ADUR DISTRICT COUNCIL

Adur Planning Committee	
Date:	7 November 2022
Time:	7.00 pm
Venue:	QEII Room, Shoreham Centre, Shoreham-by-Sea

Agenda Item 6

Application Number:	AWDM/0607/22	Recommendation - Approve
Site:	Garage Compound Rear Of Kingston Broadway Hawkins Road Shoreham-by-Sea	
Proposal:	Demolition of existing buildings (B1 and B8) and construction of 5no. two bedroom Live/Work mews dwellings.	
Applicant:	Mr Ben Hurd	Ward: Hillside
Agent:	7 Surveying & Construction Management Ltd	
Case Officer:	Peter Barnett

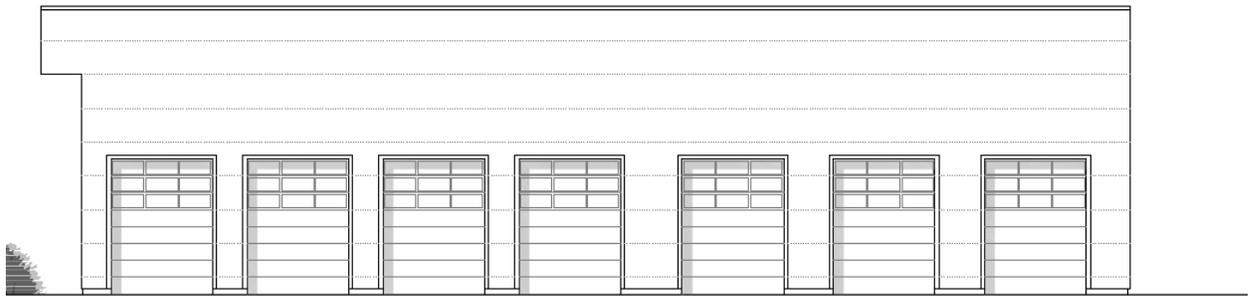
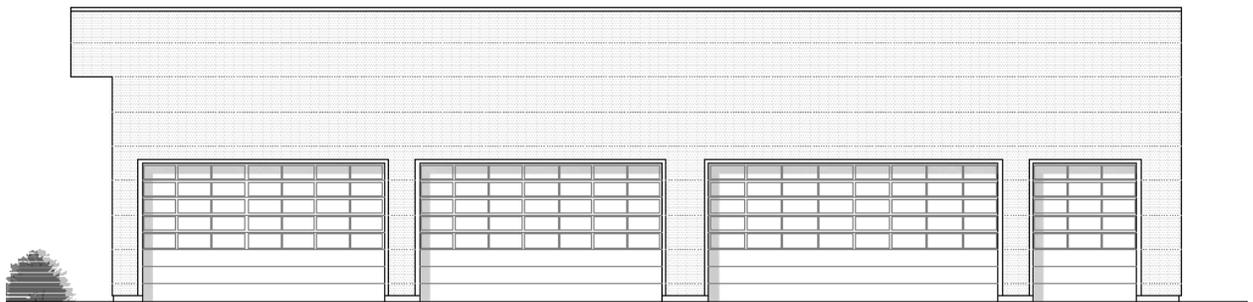
This application seeks approval for a change to the proposed external cladding colour and to alter roller shutter door openings to the rear (western) elevation.

The other change relates to the roller shutters on the west elevation. As approved there were 7no. smaller openings proposed as below:

The amendment now shows 3no. larger openings plus 1no. smaller one:

The change to the roller shutter doors will not have a significant visual impact, resulting in fewer, but larger, openings. The western boundary will consist of a 1.8m high acoustic fence which will partly screen the building and it is not considered that any increased visual harm will arise from this proposed change.

As Approved

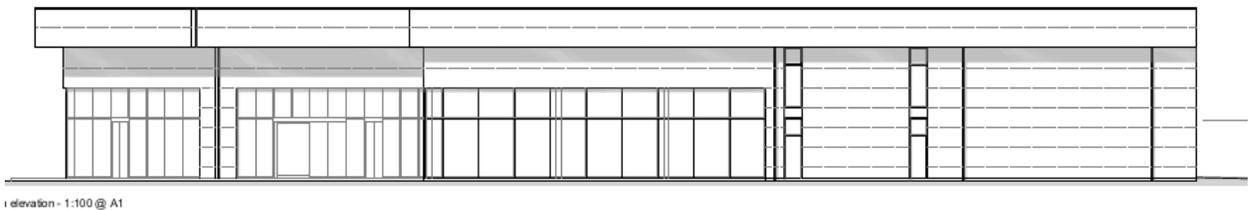
At the November 2021 Committee, Councillors raised concerns regarding the CGI image which differed from the submitted plans. An improvement in the appearance of the proposed building was requested and this was achieved with the introduction of roof overhangs/projecting canopies to create a shadow line and less of a plain, industrial 'box'.

The consideration now is whether the change to a black finish rather than silver would be harmful to the character of the area.

Overall it is considered that the change to the cladding colour is acceptable in this location.
